# Authorized Field Change

AFC 12931

**Subject:** Diesel Particulate Filter (DPF) Temperature Sensor Harness Reinstallation

Model: PB105 and PB405, BE and CE Bus

**Figure 1. DPF Harness: Original Installation.**

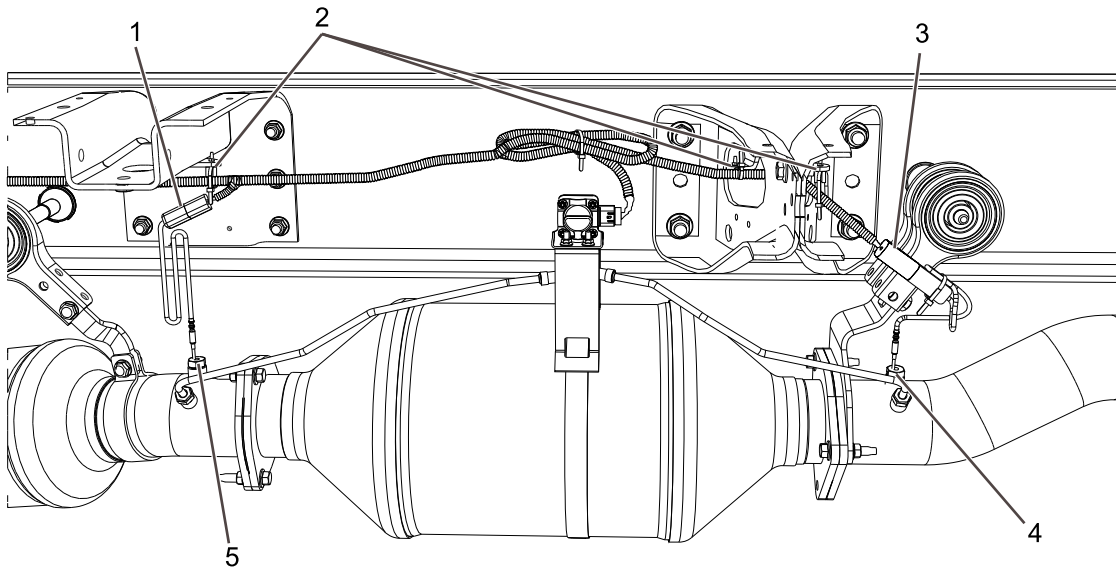
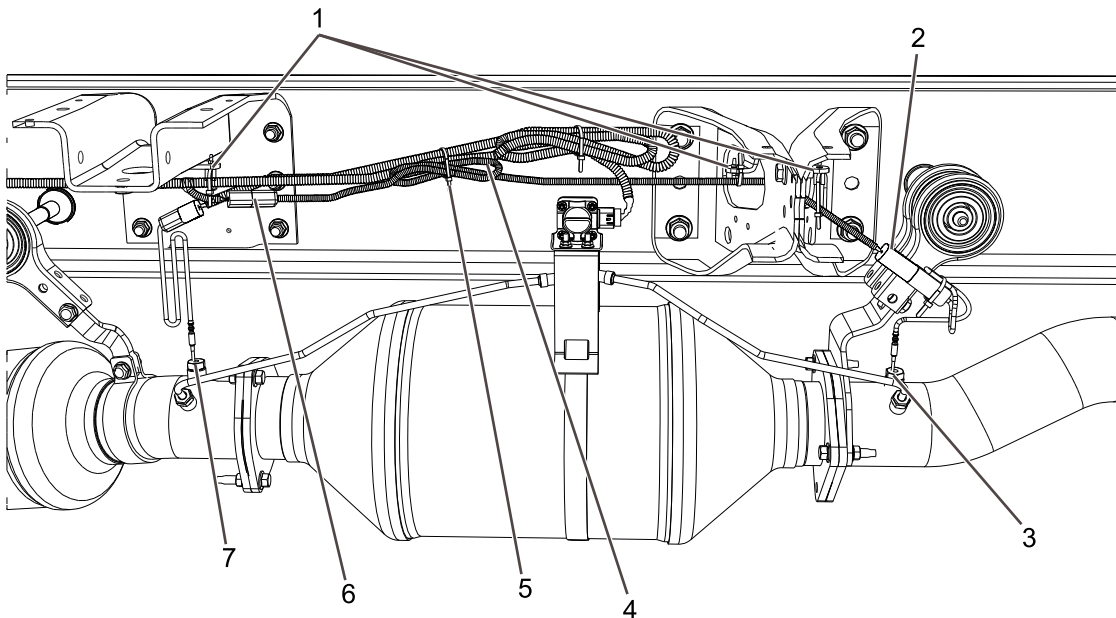
The following procedures outline the process to install the jumper harness between the Diesel Particulate Filter (DPF) inlet and DPF outlet connectors. Repair consists of installing a jumper harness from the chassis harness DPF inlet connector to the DPF outlet sensor, and connecting the chassis harness DPF outlet connector to the DPF inlet sensor. This process will include connecting the unit to ServiceMaxx™ to verify signals are as expected after repair.

5. Remove existing tie straps (Figure 1, Item 2) from right-side frame rail at DPF inlet sensor connector, right-side frame rail forward of cross member at rear of DPF, and right-side frame rail rear of cross member above DPF outlet sensor.
6. Reroute DPF outlet chassis harness connector (Figure 1, Item 3) through right-side chassis cross member toward DPF inlet temperature sensor (Figure 1, Item 5).
7. Disconnect DPF inlet temperature sensor (Figure 1, Item 5) from chassis harness connector (Figure 1, Item 1) and connect DPF inlet sensor connector to DPF outlet chassis harness connector (Figure 1, Item 3).

8. Connect jumper harness (Figure 2, Item 4) to DPF inlet chassis harness connector (Figure 2, Item 6).
9. Route jumper harness (Figure 2, Item 6) through right-side chassis cross member to DPF outlet sensor (Figure 2, Item 3).

10. Connect jumper harness connector (Figure 2, Item 2) to DPF outlet temperature sensor (Figure 2, Item 3).
11. Install tie strap securing jumper harness at right-side frame rail rear of cross member above DPF outlet sensor (Figure 2, Item 1). Position jumper harness connector (Figure 2, Item 2) to allow adequate slack and tighten tie strap.

12. Install tie strap securing jumper harness at right-side frame rail forward of cross member above DPF assembly (Figure 2, Item 1) and tighten tie strap.

13. Install tie strap at DPF inlet sensor connector (Figure 2, Item 1). Adjust all harnesses to ensure appropriate slack forward of this clipping point and to sensor. Tighten tie strap.

14. Remaining jumper harness and chassis harness must be bundled and clipped using an additional tie strap (Figure 2, Item 5).
